PCO #076

Project: 21-501 - Collin County Adult Detention Facility, Phase 1 Addition
4300 Community Avenue
McKinney, Texas 75071

Prime Contract Potential Change Order #076: RFI #233 Ductwork Modifications in Chases

RFI #233: HOT RFI: HVAC Clarifications Per MD Site Walk on 12.5.23

RFI 233

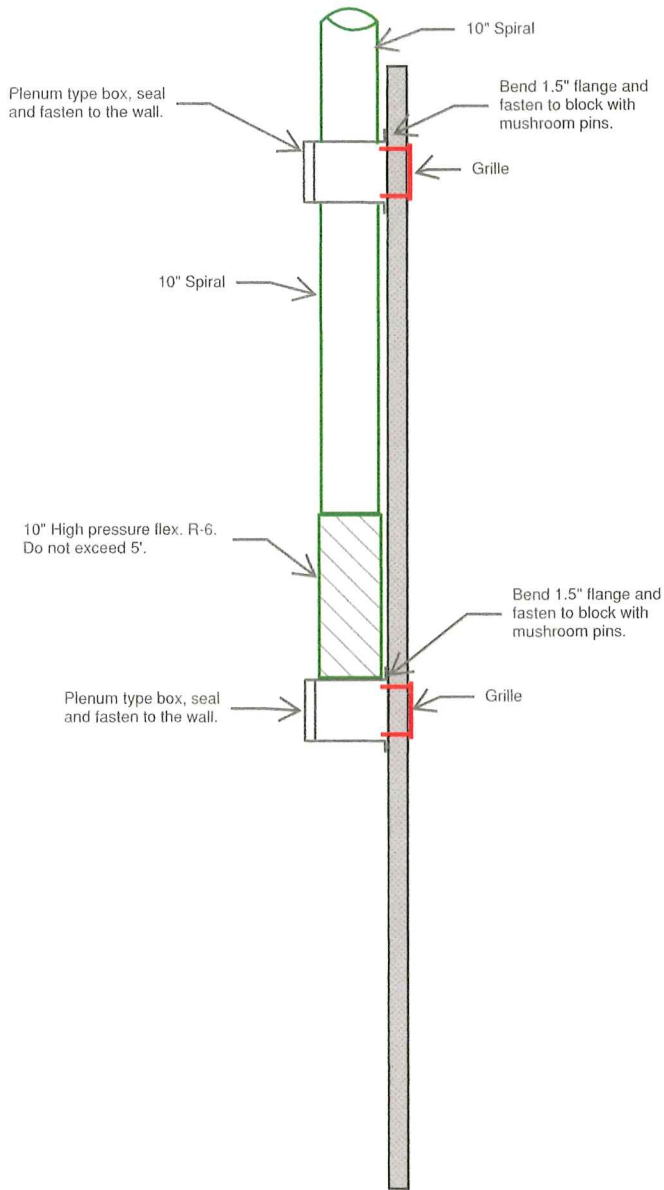
1. Can we clarify on the on the direction we got from the engineer on the insulation inside the chaises? He said he wanted to change the insulation from R-11 to R-6.

2. Can we clarify on changing the spiral duct work going from tier level to level 1 to high pressure flex duct work and is it R-6? (can we please get a drawn description of how you would like this done?)

3. Can we clarify on changing the tap for the grills in all the cells to construct a piece of duct work that ties into the CMU wall?
4. Can we also clarify how the engineer would like us to run the 26x10 duct work in the tier level in rooms 3205, 3206, &3207?)(See marked up drawing)

5. Can we also get clarification on plumbing chaise CH16? This is the one where I think we were going to change the supply to 10" Spiral and the return to 6" spiral. (See marked ---up drawing)

6. Can we clarify what size spiral we are needing to install into all mechanical chassis?
7. Can we clarify If we can move the duct work 22" East so we do not core through that entire section of wall that the duct passes through? (see marked up drawings for reference)

1. It is acceptable to use R-8 / R-6 Installed insulation in the home plate shaped plumbing chases only.
2. It is acceptable to utilize high pressure flex on the supply / air make up duct in the home plate shaped plumbing chases only. The flex is not to exceed 5'. See attached detail.

3. At grille locations in the plumbing chases, provide a tap can that fastened to the cinderblock. Seal all connections to the block. See attached details.

- b. The Plumbing contractor will have to relocate the 2 pipes he has dropping vertically into the pipe chase.
5. The return can be changed to 10" on the upper level and 8" on the lower level. The Supply can be changed to 10". The return will need to be routed around the plumbing pipe in the chase.

6. See attached detail for home plate chases duct sizing.
7. MD takes No Exceptions to relocating the duct.
8. Contractor is allowed to route pipe as necessary.
